Product Change Notice (PCN)

PCN Number: PCN-0456180R-02

Product(s) Affected: *PJ-041H*

PREVIOUS CUI DEVICES DETAIL / IMAGE	NEW CUI DEVICES DETAIL / IMAGE

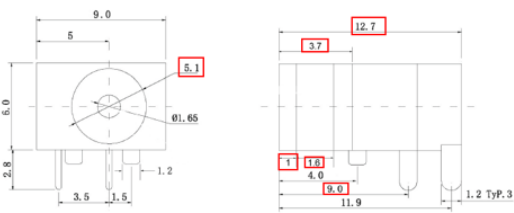
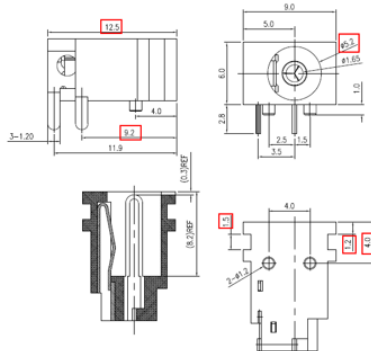
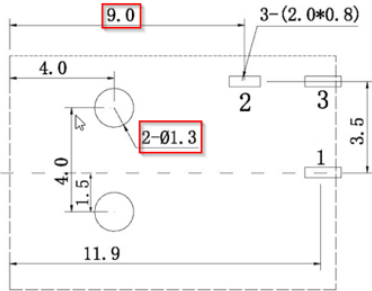
Description of Change: *New Factory Location. Product re-engineered for improved manufacturability and production yield. See image below for reference and check CUI Devices website for updated drawing. Cosmetic differences may be visible and not affect the form fit and function of the product.*

PREVIOUS CUI DEVICES DETAIL / IMAGE			NEW CUI DEVICES DETAIL / IMAGE		
DESCRIPTION	MATERIAL	PLATING/COLOR	DESCRIPTION	MATERIAL	PLATING/COLOR
center pin	brass	silver	center pin	copper alloy	silver
terminal 1	brass	silver	terminal 1	copper alloy	silver
terminal 2	C5191 phosphor bronze t=0.30	silver	terminal 2	copper alloy	silver
terminal 3	C5210 brass t=0.30	silver	terminal 3	copper alloy	silver
housing	PA66 (UL94V-0)	black	housing	PPA (UL94V-0)	black

<p>MATING PLUG Jack Insertion Depth 8.9 mm</p>	 <p>MATING PLUG Jack Insertion Depth 8.2 mm</p>
---	--
